RE: **PETITION NO. 1567** - The Connecticut Light and Power Company d/b/a Eversource Energy Declaratory Ruling, pursuant to Connecticut General Statutes §4-176 and §16-50k, for the 1637/1720 Lines Rebuild Project consisting of the replacement and reconductoring of electric transmission line structures along its existing 4.0 mile electric transmission line right-of-way shared by its existing 115-kilovolt (kV) Nos. 1637 and 1720 Lines between Grist Mill Road in Norwalk, Norwalk Junction in Wilton, and Weston Substation in Weston, Connecticut traversing the municipalities of Norwalk, Wilton, and Weston, and related electric transmission line and substation improvements. **Request for Project Change.**

Re: **PETITION NO. 1567** – The Connecticut Light and Power Company d/b/a Eversource Energy (“Eversource”) petition for a declaratory ruling for the 1637/1720 Lines Rebuild Project Proposed Project Modification

**1637/1720 Lines Rebuild Project  
Petition Map Set**

Norwalk & Wilton, CT      MAP SHEET 1 of 8

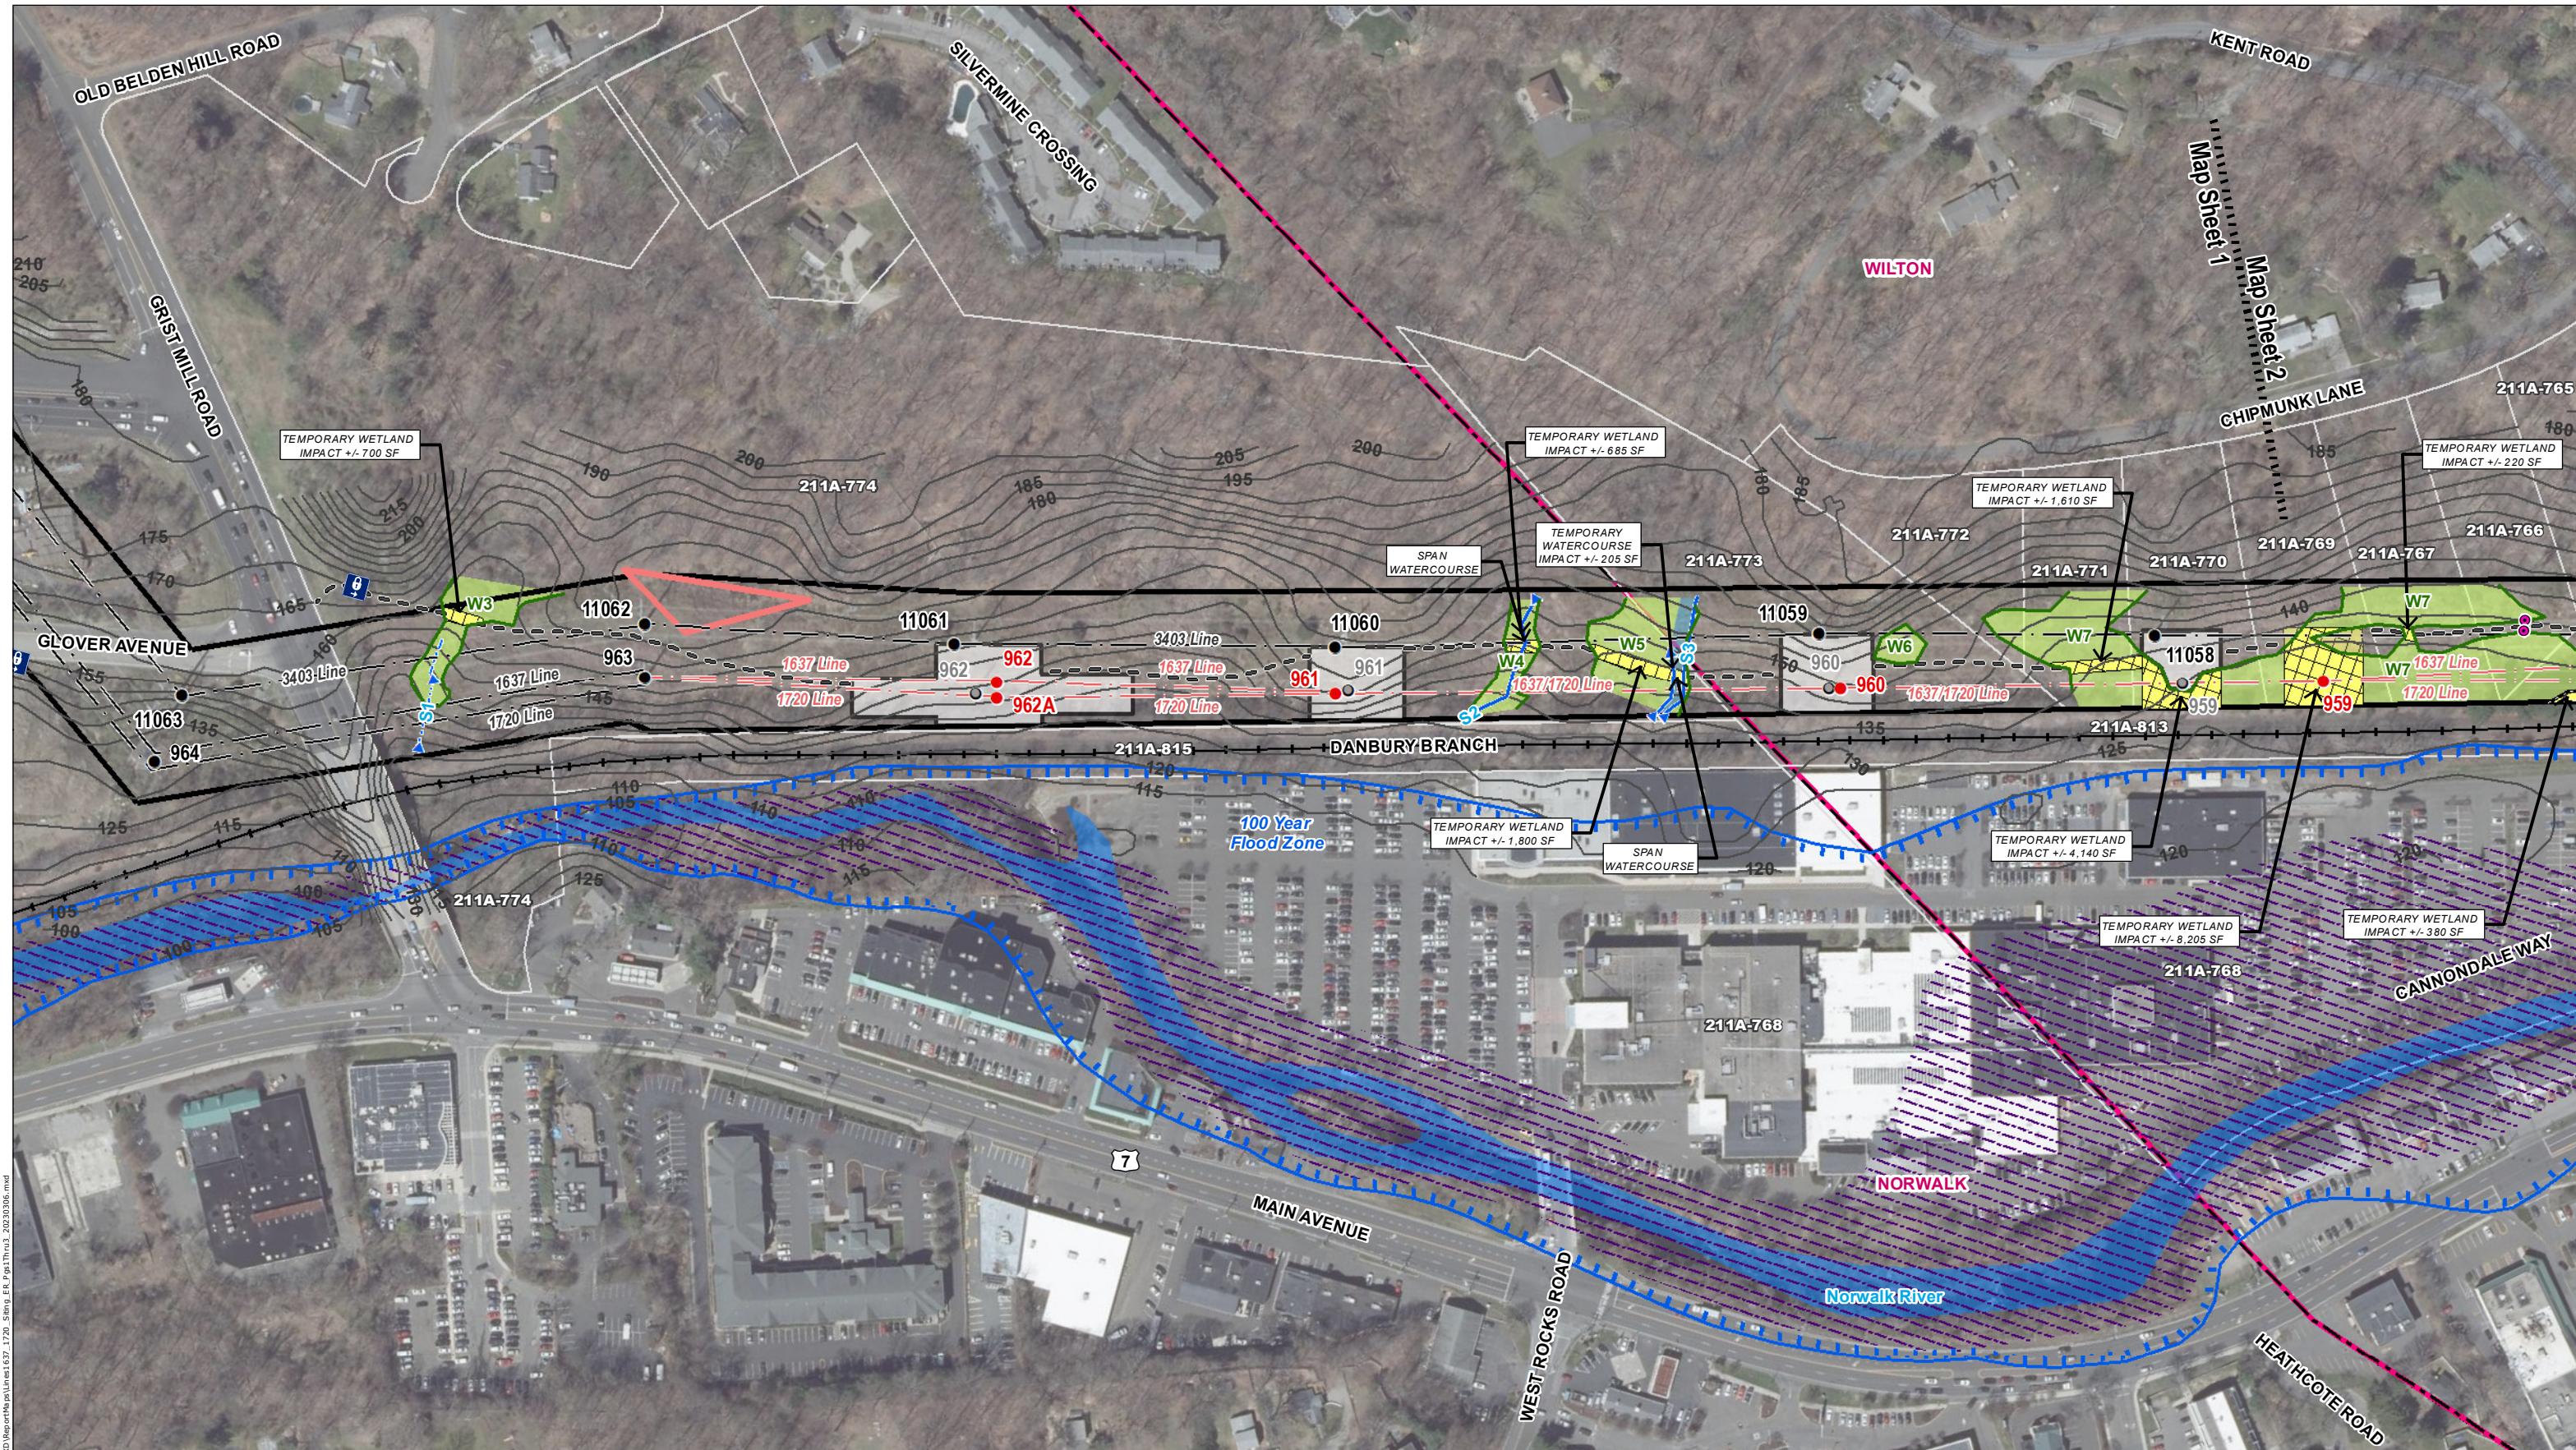
On September 15, 2023, the Connecticut Siting Council (“Council”) issued a declaratory ruling on Petition No. 1567 as referenced above. In accordance with Condition No. 1 of the ruling, Eversource is seeking Council staff approval for a proposed project change, shifting proposed Structure 961 placement by approximately thirty feet southwesterly, as shown on Attachment A - Map Sheet 1.

Upon closer review when starting construction, it was determined that shifting this proposed structure to a less steep location mitigates safety concerns due to the terrain at the original location of this proposed structure.

This proposed modification will not result in any additional environmental effects as presented in the Petition.

Pursuant to Condition No. 1 of the Council's September 15, 2023 Declaratory Ruling, your request to shift replacement Structure 961 by approximately thirty feet to the southwest is hereby approved.
